February 3, 2020

RE: Marisol Specific Plan Initiative Draft Environmental Impact Report

Exhibit 2, Page 29 of CDP 6-00-009

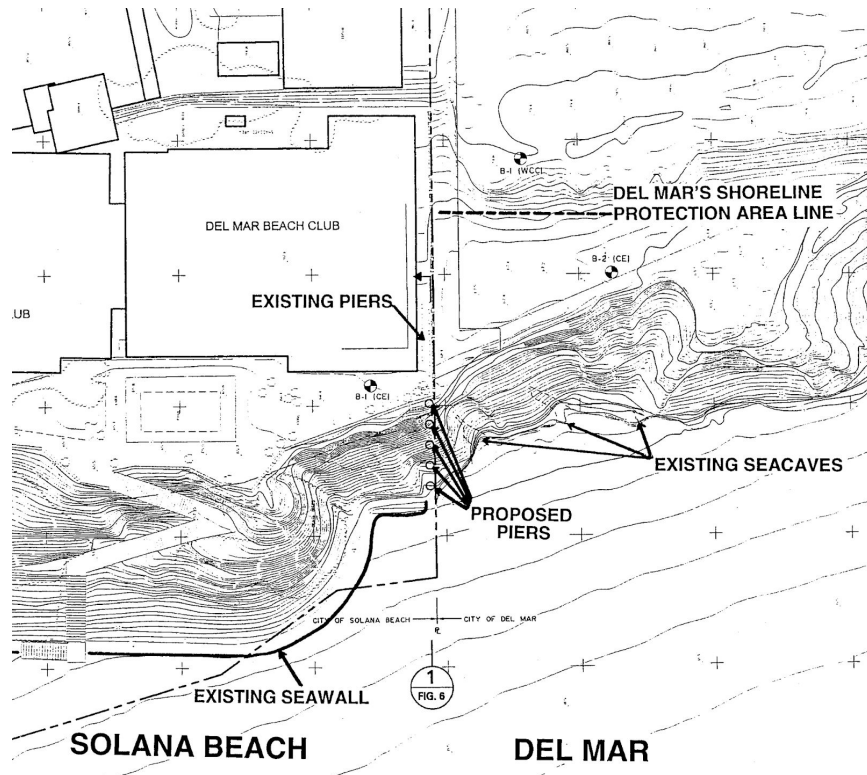
The first relevant study that should be included to calculate setbacks and bluff retreat is a 2009 erosion study for a permit to the Coastal Commission for a network of piers immediately adjacent to the subject site at the Del Mar Beach Club in Solana Beach. Erosion from the Marisol proposed site necessitated the need for these piers. Coastal Development Permit 6-00-009² at the Del Mar Beach Club stated the observed erosion rates were 0.8ft/year in 2001. This is almost five times faster than the historical rate Geocon used to calculate the 75-year bluff retreat value.

The Del Mar Beach Club in Solana Beach is adjacent to and immediately north of the Marisol site:

Figure 3-1, Marisol DEIR Land Use Plan

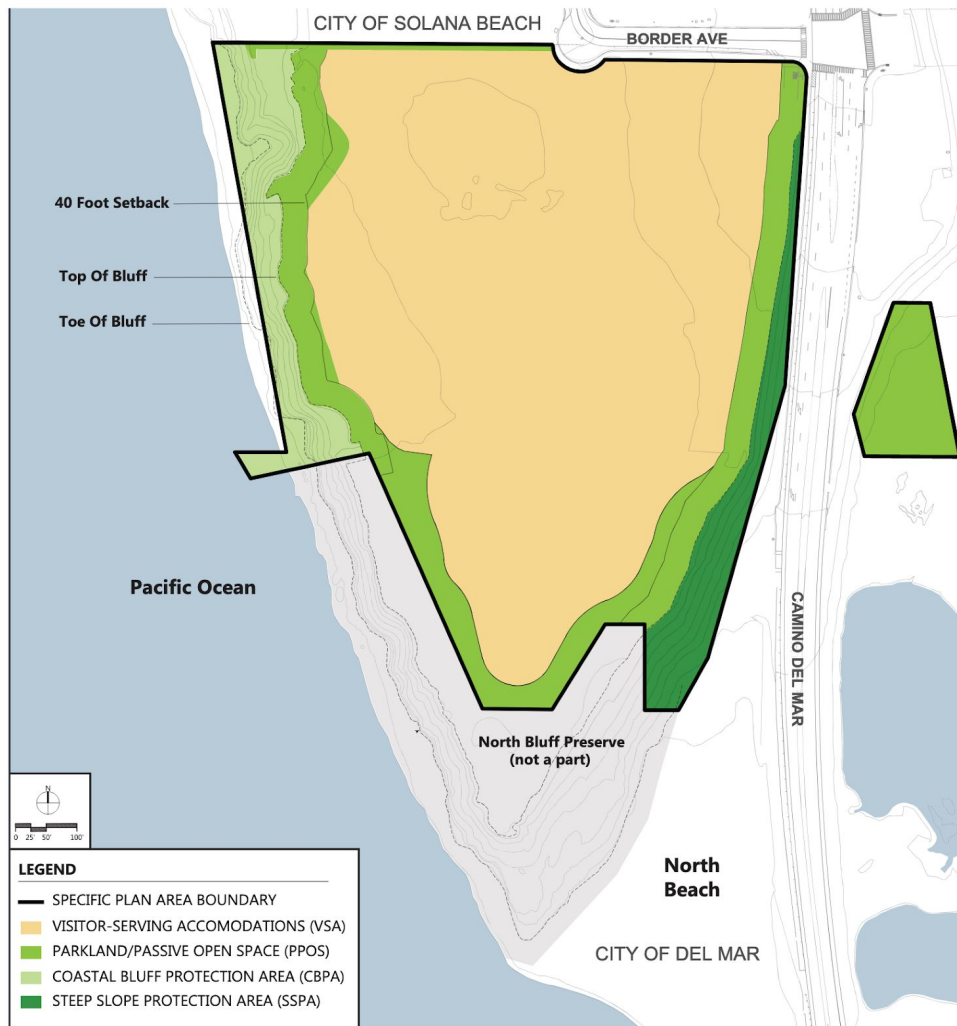
In addition to blufftop access not being unique to the proposed Marisol project, public access will be the first thing lost when the bluff erodes. Figure 3-1 from Marisol DEIR delineates the property and proposed 40 foot setback in its Land Use Plan.

Figure 3-2, Marisol DEIR Conceptual Plan

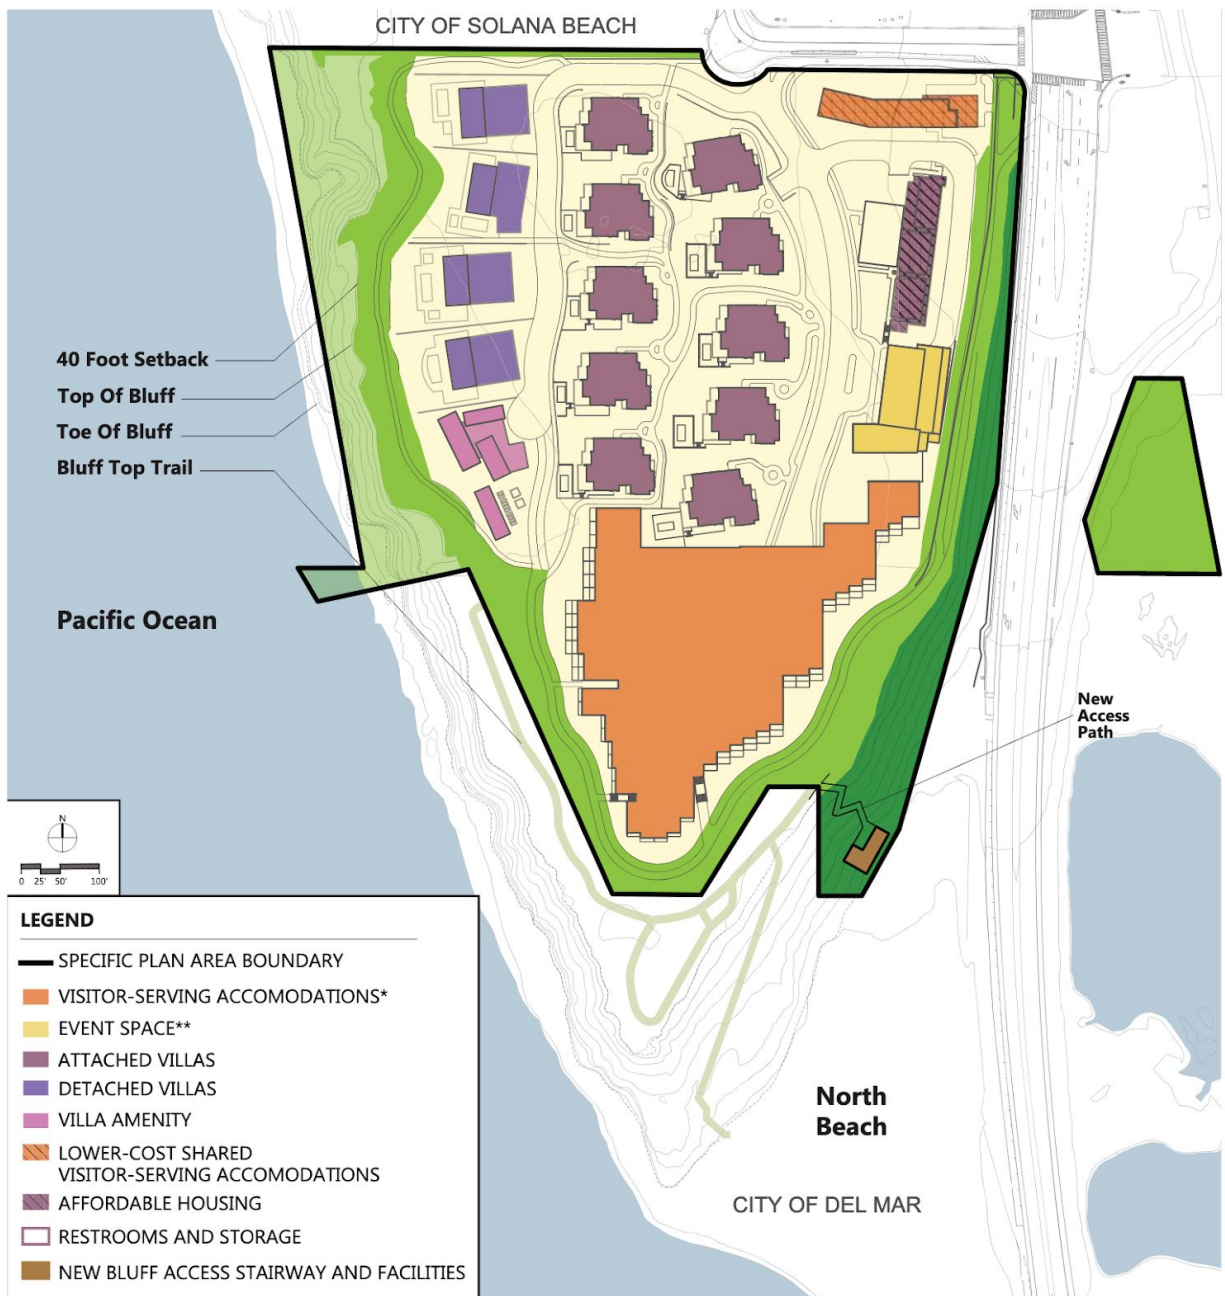
The subsequent Figure 3-2, Conceptual Site Plan shows how the blufftop public access is seaward of the 40 ft setback (Additionally, there is an error in this figure that also should be addressed. The 40 ft setback should indicate the inner, landward edge of the medium green color. This figure currently indicates that the setback and top of bluff are the same line).

The proposed public trail is clearly within the area of the property that may soon be lost to blufftop erosion. The Marisol DEIR acknowledges the likelihood of this scenario by stating that the trails should be built using lightweight materials that can be easily removed when the trail is no longer safe.

Figure 3-1, Land Use, CPBA in light green

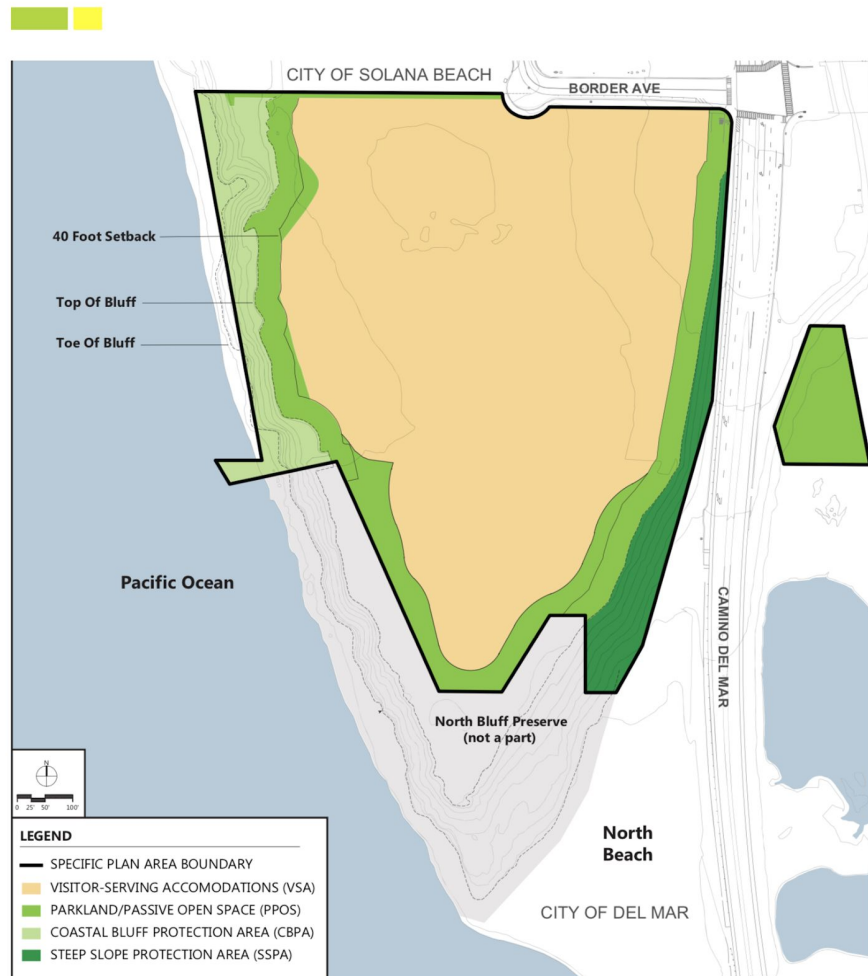
While there is no seawall in the specific plan there is no prohibition on a future sea wall. The DEIR is specific that there are no seawalls allowed in the Coastal Bluff Protection Area (CBPA):

However, once the bluff has eroded landward past the demarcation of the CPBA, Del Mar Municipal Code allows for seawalls behind the Shoreline Protective Area Line. Essentially, the DEIR states that it will not allow shoreline protective devices until the bluffs have eroded beyond the CPBA. Once the CPBA has been sacrificed to SLR and the private portions of the development are threatened, shoreline protective devices could be potentially allowed. This is a reasonable fear, as Del Mar
